Grimes Planning and Zoning Commission Agenda

**Grimes Planning & Zoning Commission Meeting November 5, 2024
In Person at Grimes Community Complex, 410 SE Main Street, Room 202 at
5:30 PM**

RE: DeCarlo Site Plan Amendment

RE: SE 4th & Main Street Site Plan

DEMOLITION PLAN

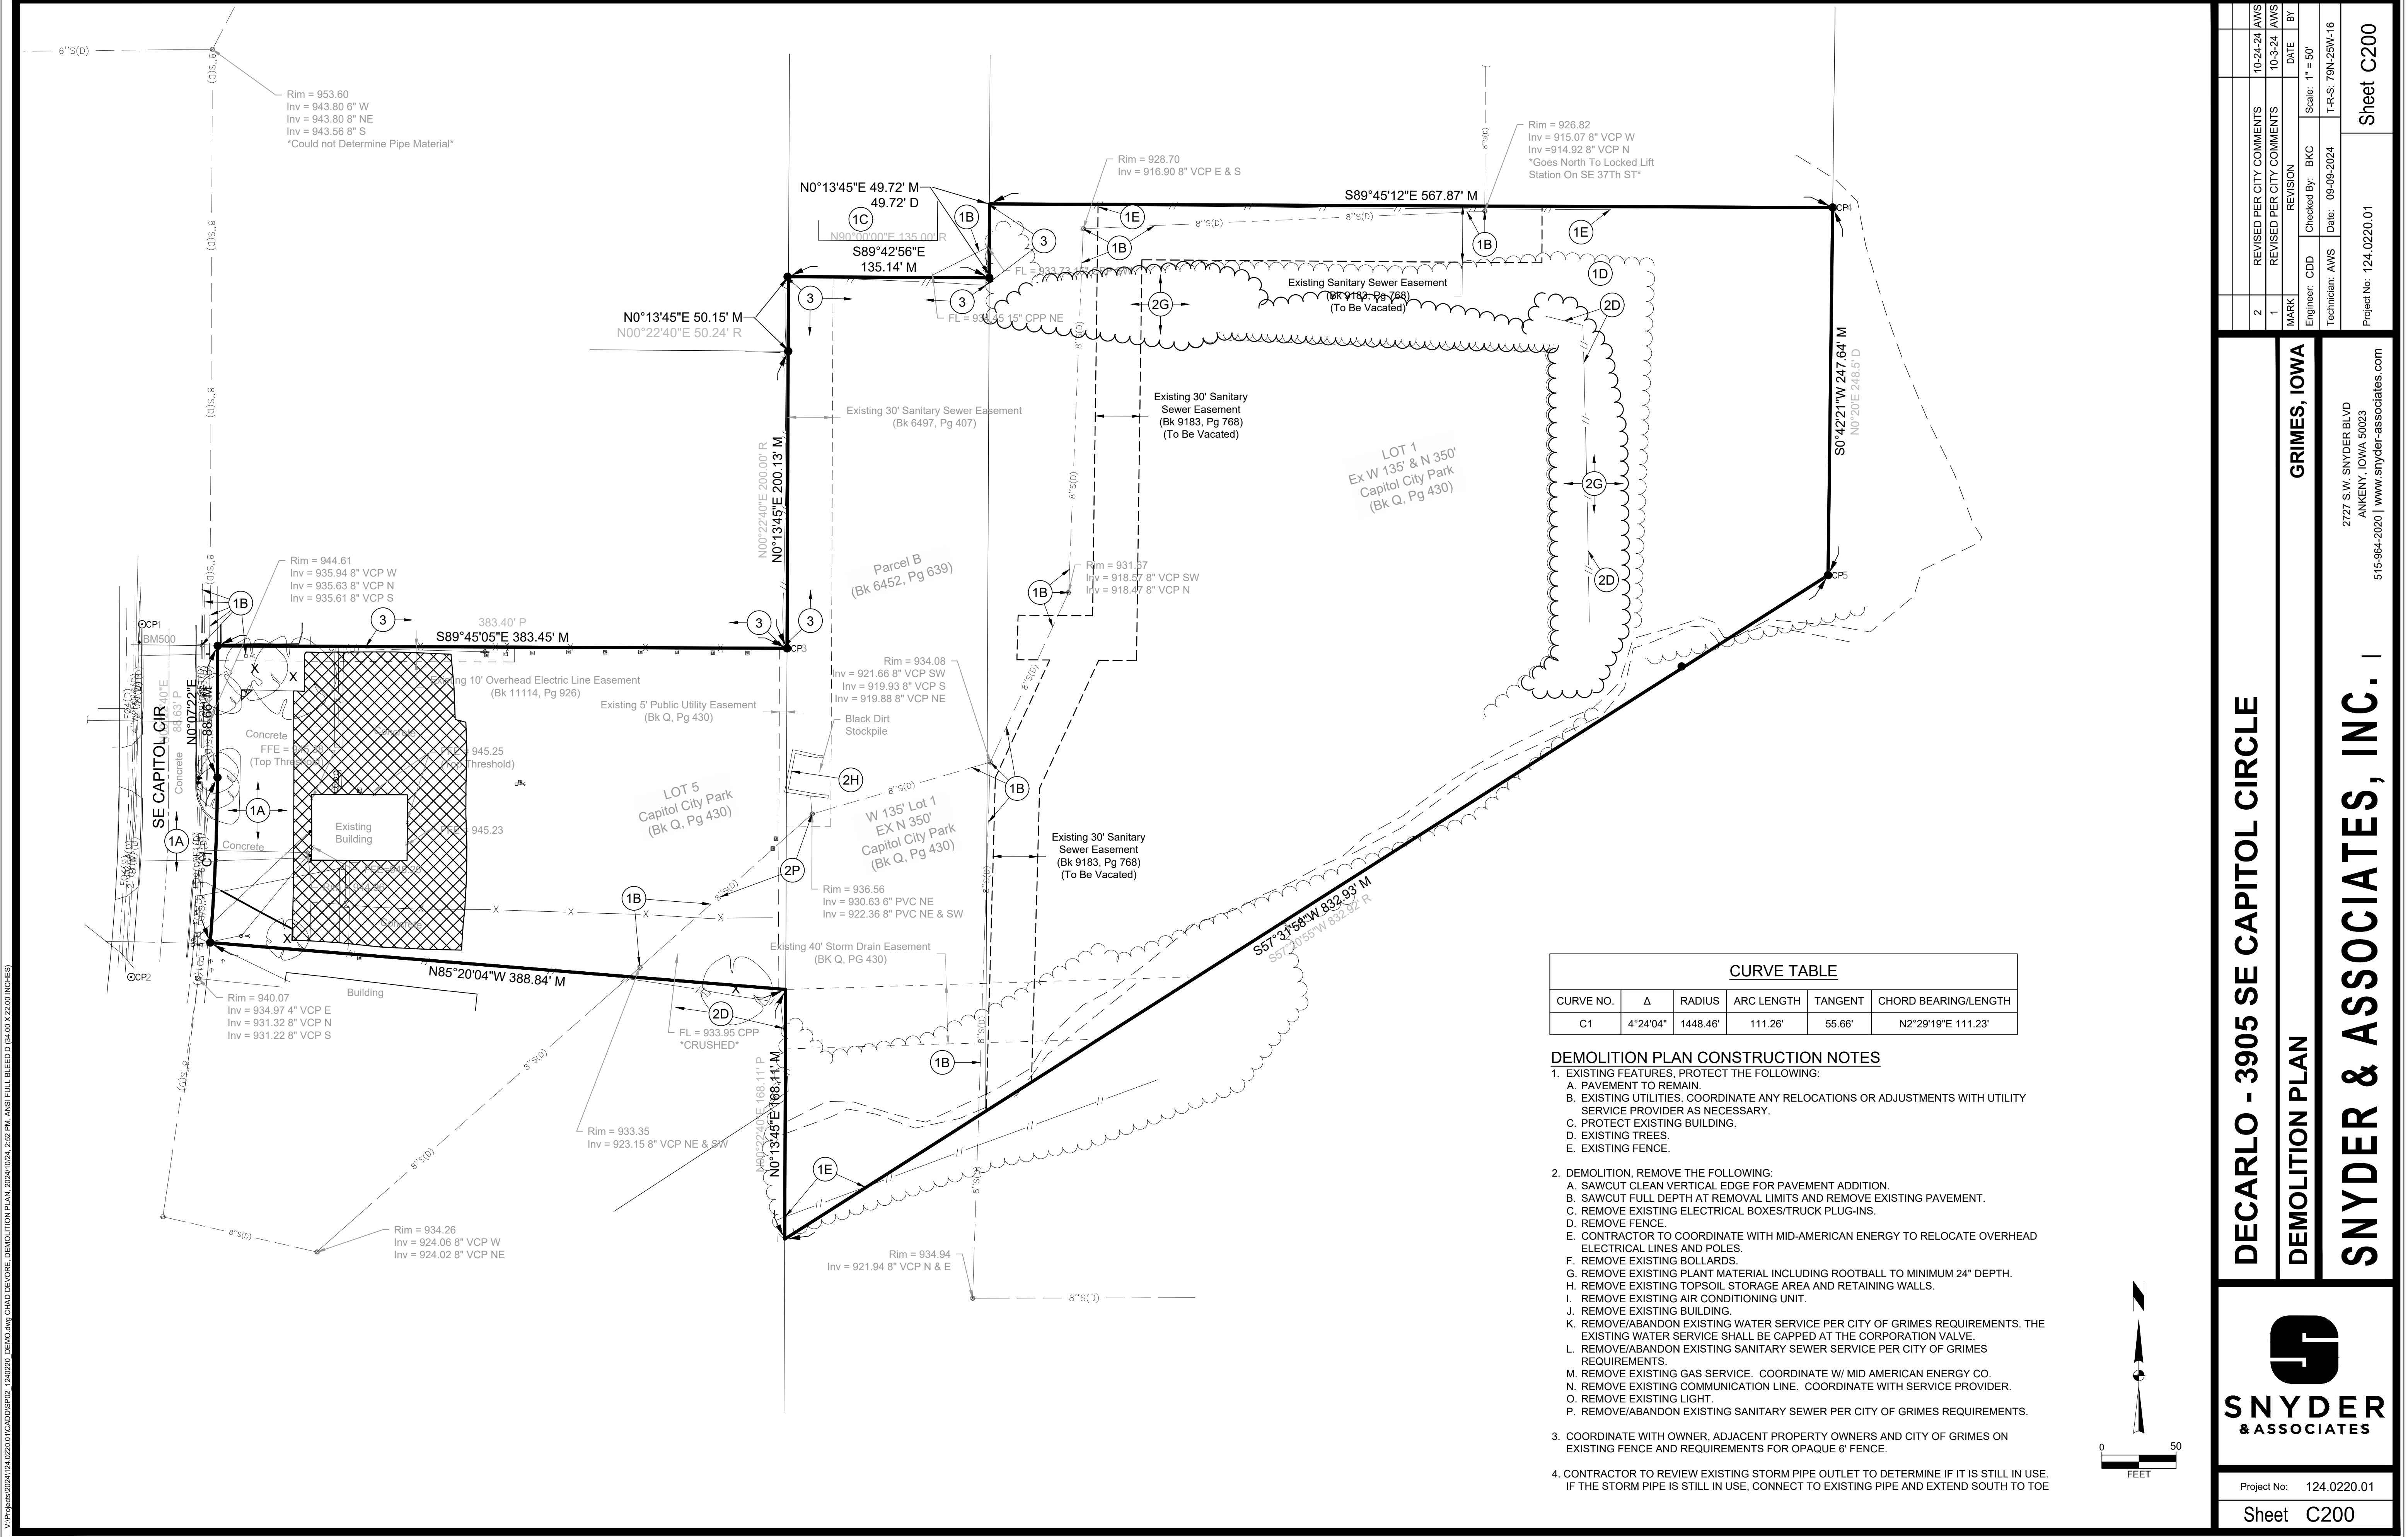
6. The southeast corner of the building crosses sanitary sewer line. The building would need to be moved so that the building would not be within a 30' sanitary easement. Alternatively, the sanitary sewer could be rerouted through the site. Rerouting would require construction drawings and would need to be designed so that the sanitary main can still be functional throughout construction. Please provide \$2000 construction drawing review fee.

LANDSCAPE PLAN

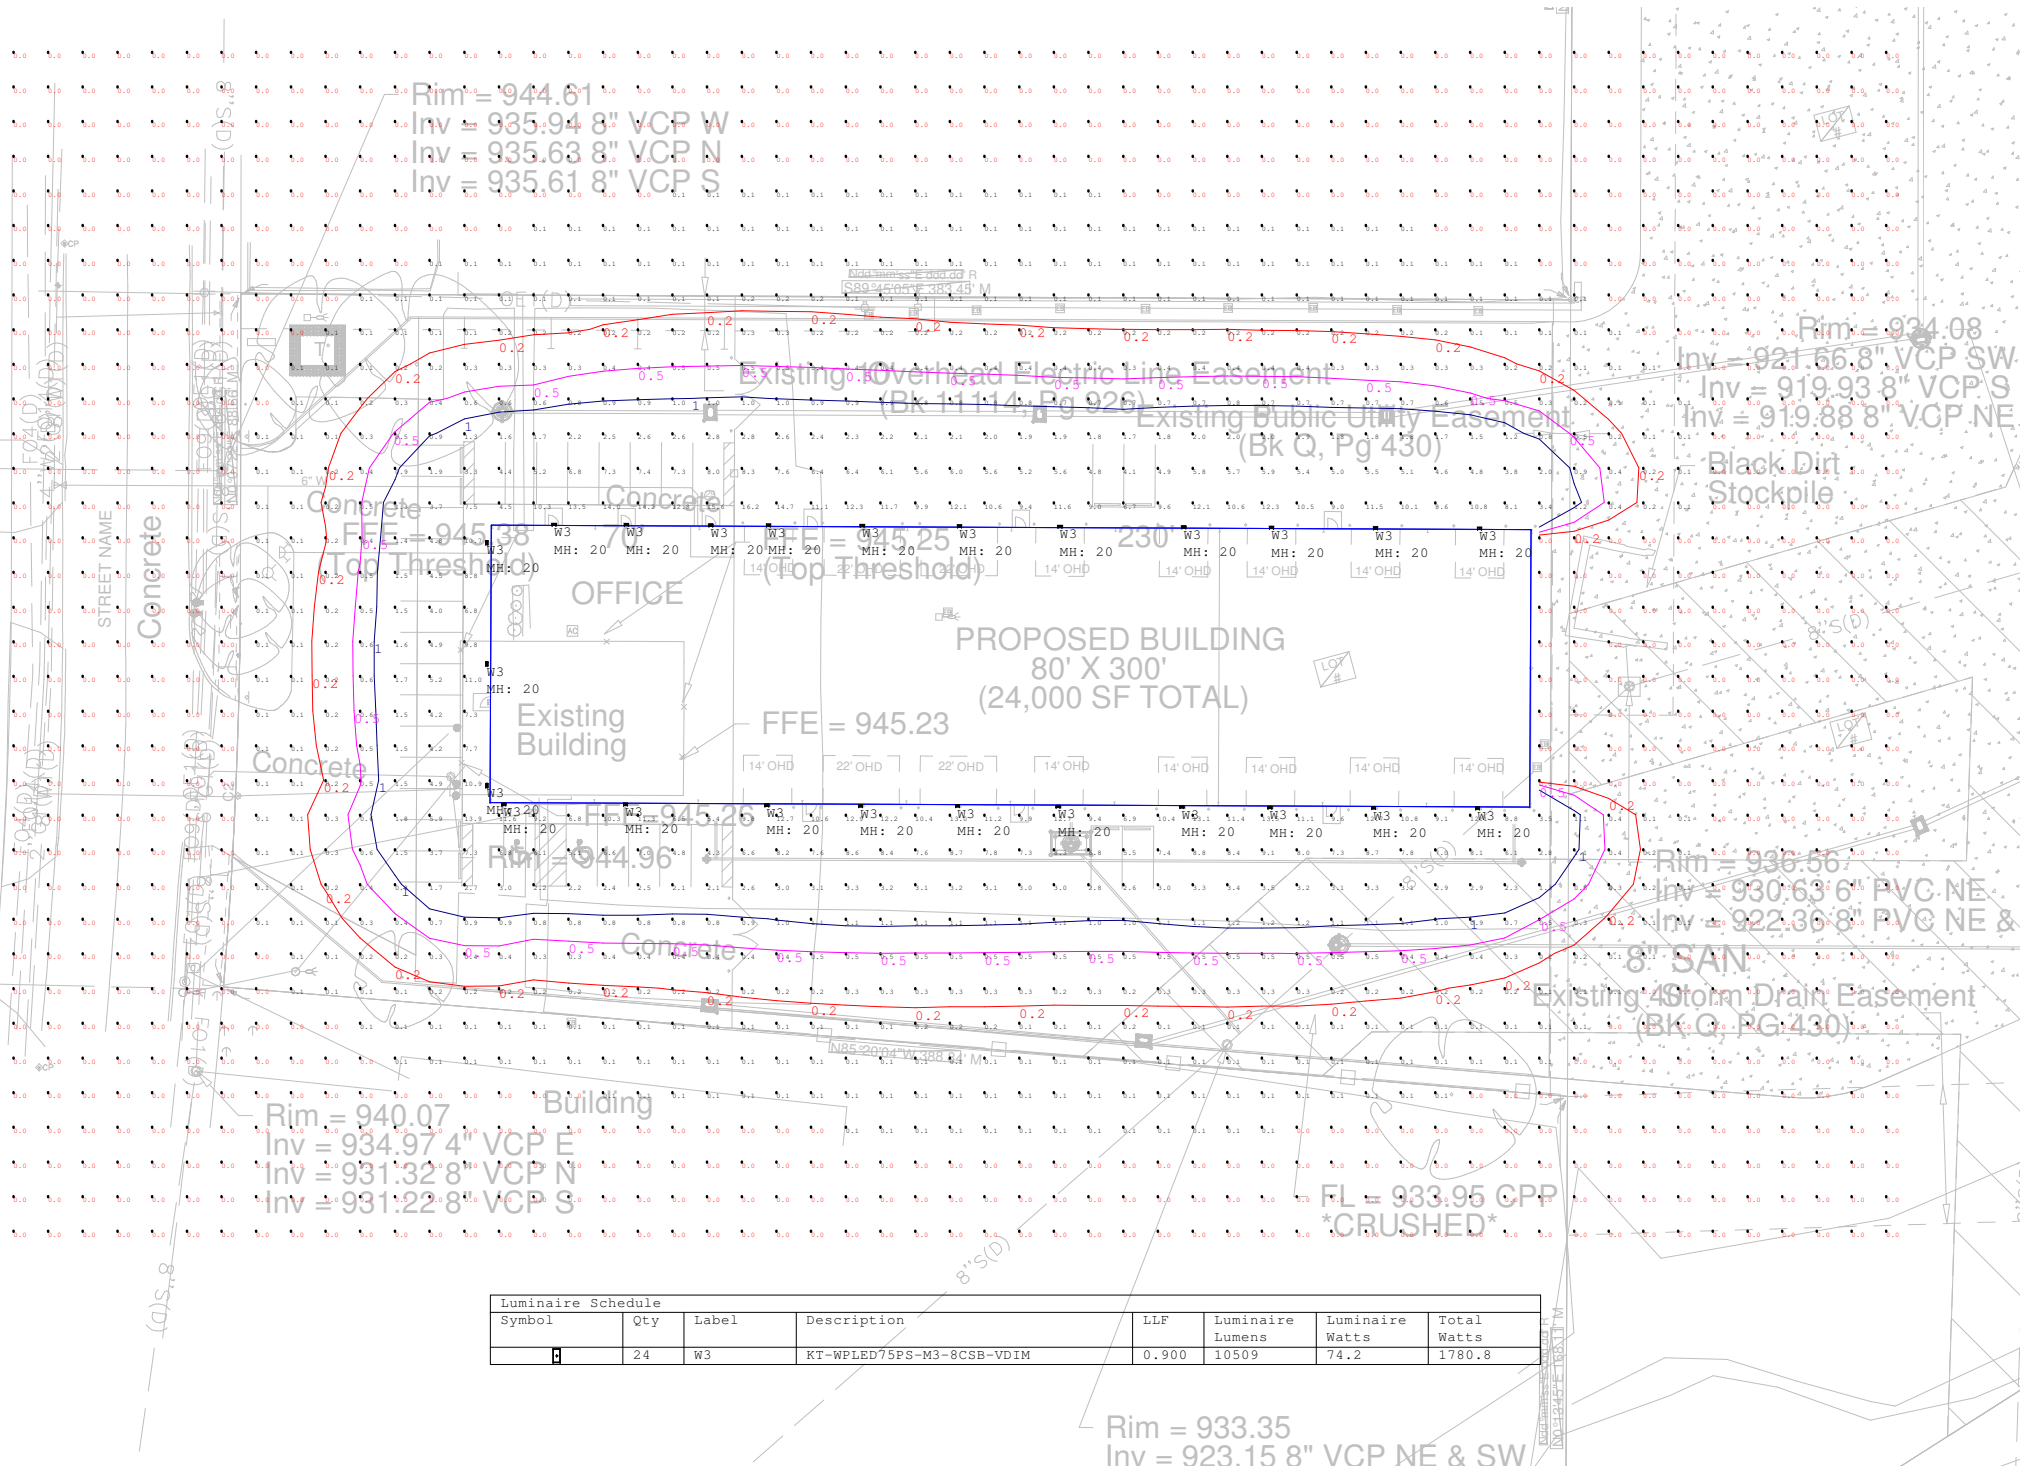
- ~~1. Provide 1 tree per 50' and 1 shrub per 4' along SE Capitol Cir. Provide frontage calculation to demonstrate compliance (i.e. 100' frontage = 2 trees, 25 shrubs) and label what is required vs proposed plantings. The number of plantings in the calculation don't match the landscape plan.~~
- ~~2. Provide 2 trees and 2 shrubs per 1000 sf of required open space. Existing, healthy trees can count toward the minimum requirements. Please provide calculation/notes to demonstrate compliance. Please update the calculation. There should be a minimum of 123 trees and 123 shrubs based on the required open space $(61,117/1000)*2$.~~

DATE: 7-30-2024
REVISIONS: 10-1-2024
10-24-2024
JOB NUMBER
CC 2326
SHEET 1 OF 6
DIMENSION PLAN
304 SE 3rd STREET

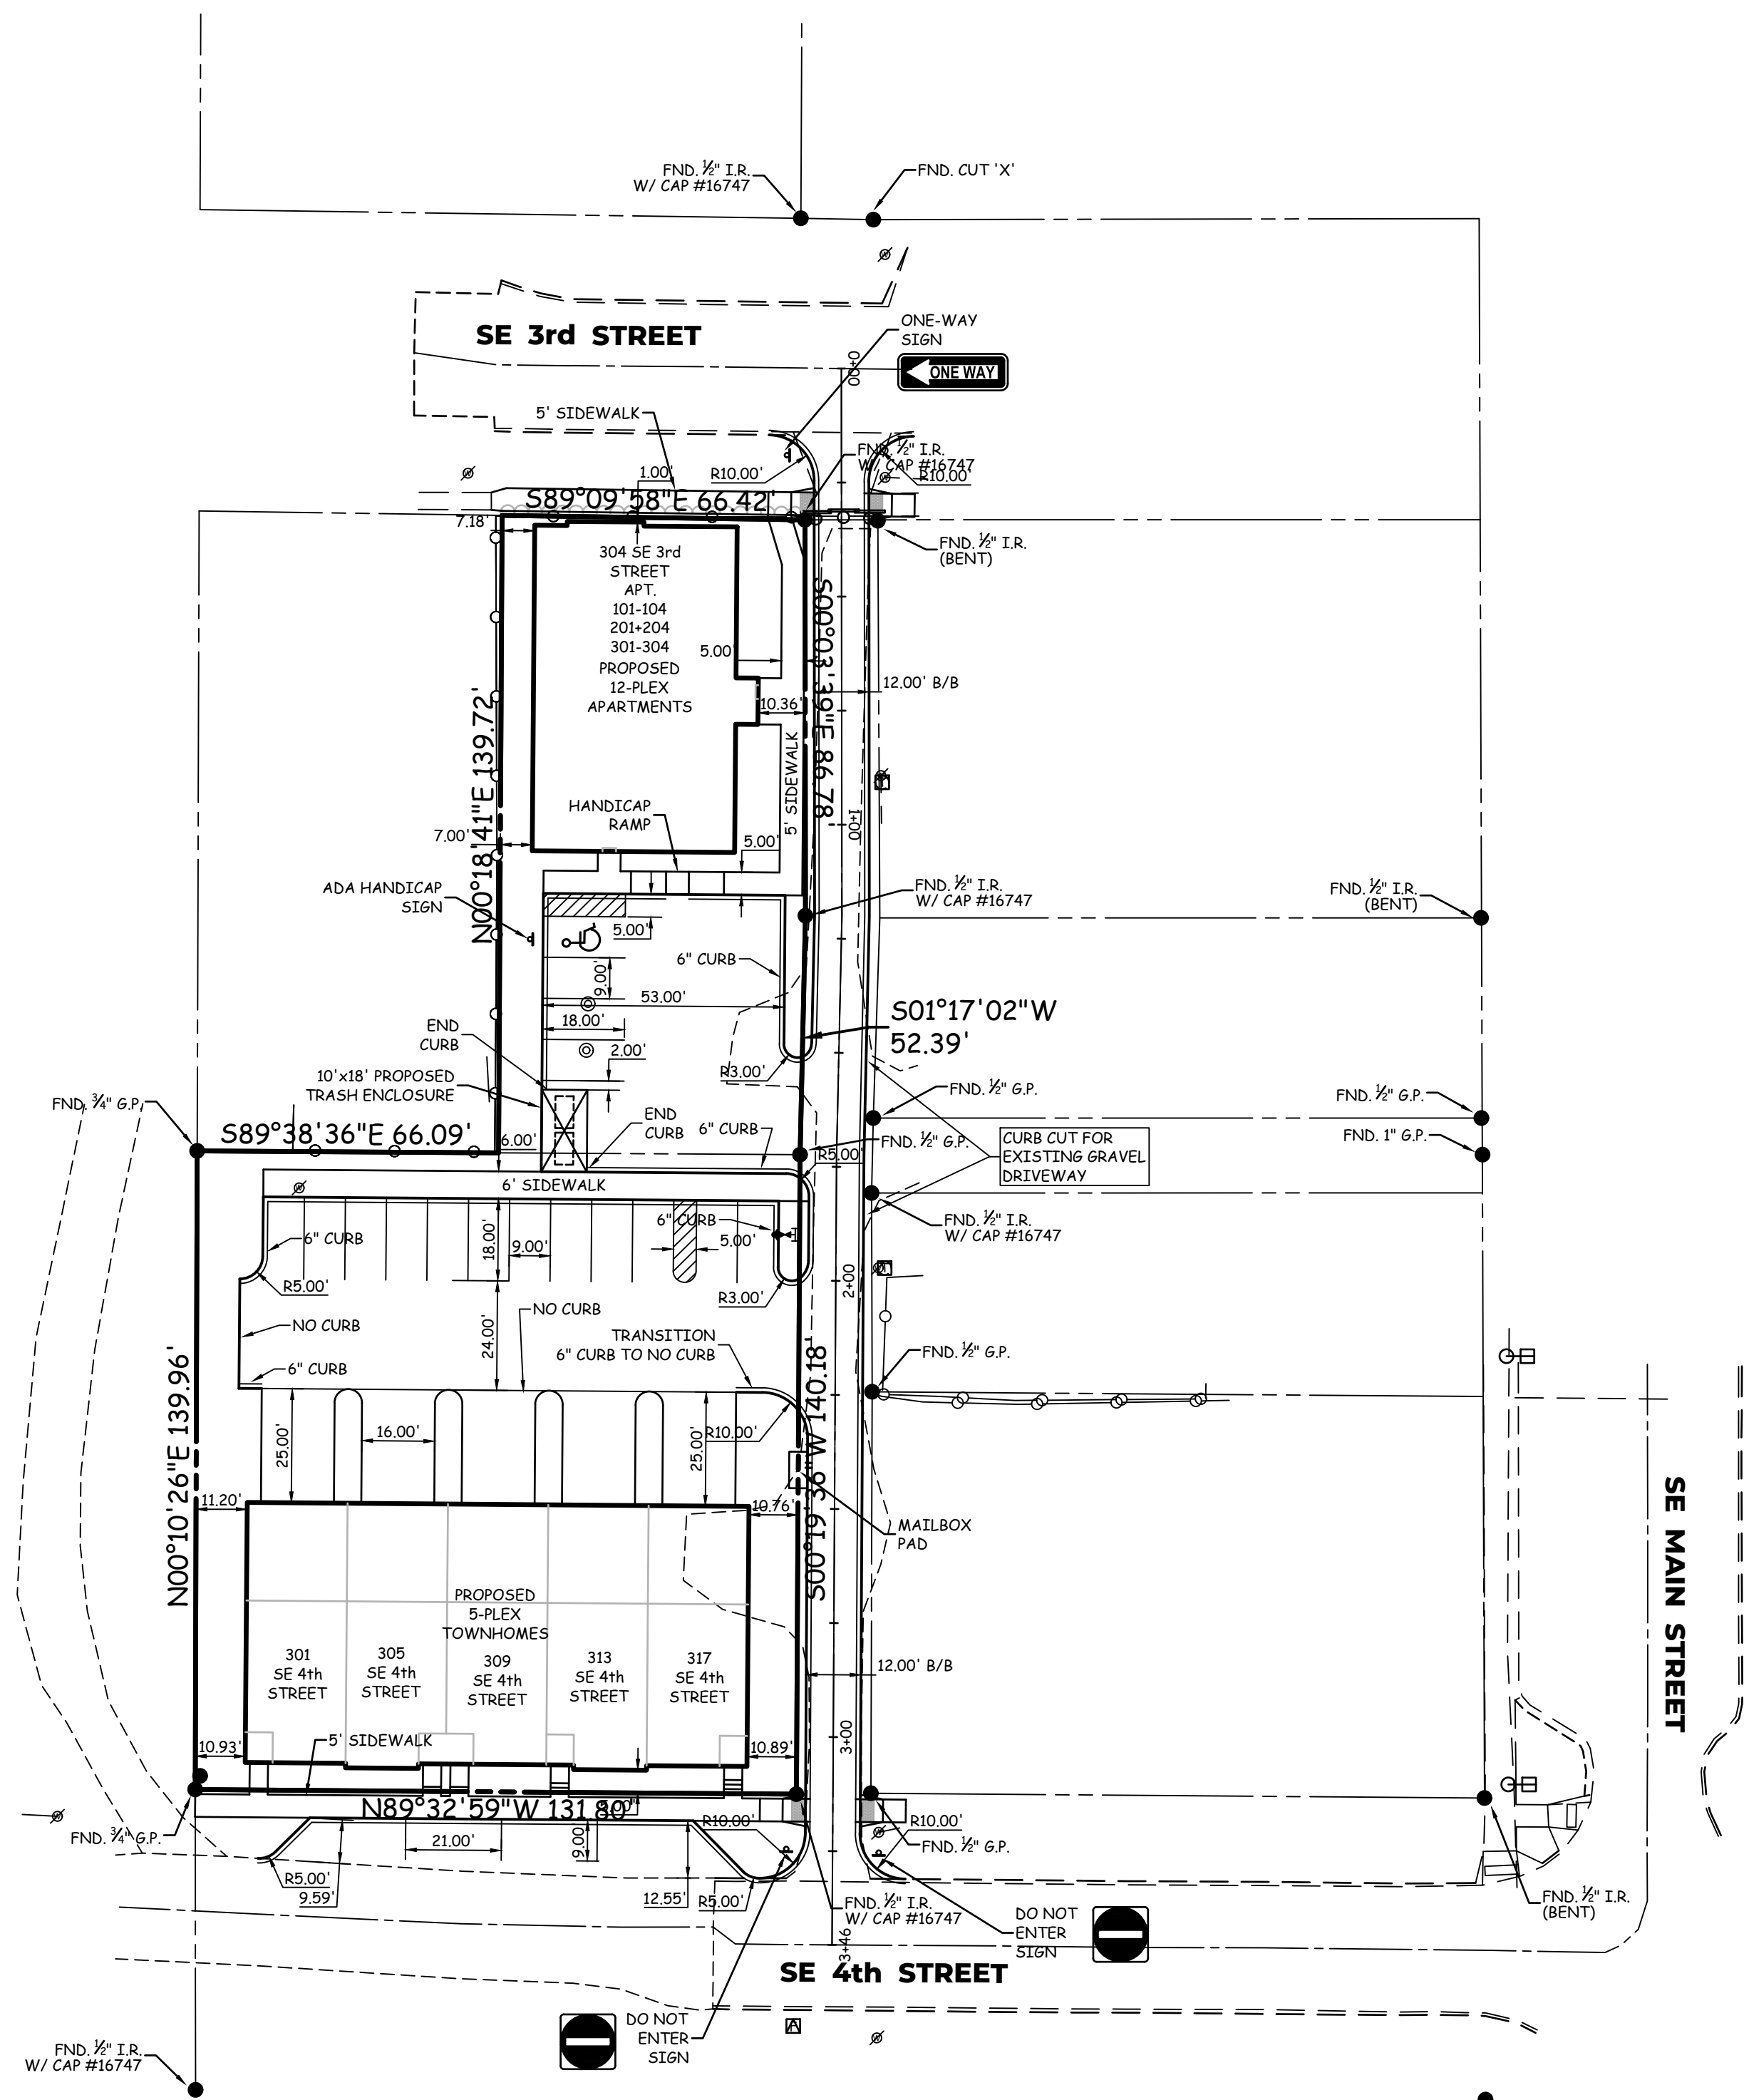
- ~~1. Update City standard notes. Notes provided.~~
- ~~2. Update zoning to R-4 (PUD) Ordinance 790.~~
- ~~3. Provide utility quantities.~~
- 4. Label mailbox location. Please add a proposed location so we can make sure there are no issues with city requirements. If the post office needs to make changes later on, the site plan can be updated. **Given the total number of units, there should be 2 mailboxes to provide enough mail slots for the units. It's likely that a 12-unit cluster would be provided for the apartments and an 8-unit cluster for the townhomes. Staff suggest providing a cluster next to each building. The cluster boxes need to be accessible. Please provide the cluster on an accessible route or provide a ramp to the mailbox pad and provide all necessary grading details.**

- 5. **Label transformer location. Has the location been coordinated with MidAmerican? What size is proposed? Label orientation of the doors.**
- ~~6. The dumpster enclosure is required to be at least 2' from the neighboring parking stall. Please revise.~~

11. Please add one-way signs opposite the two driveways on the alley.
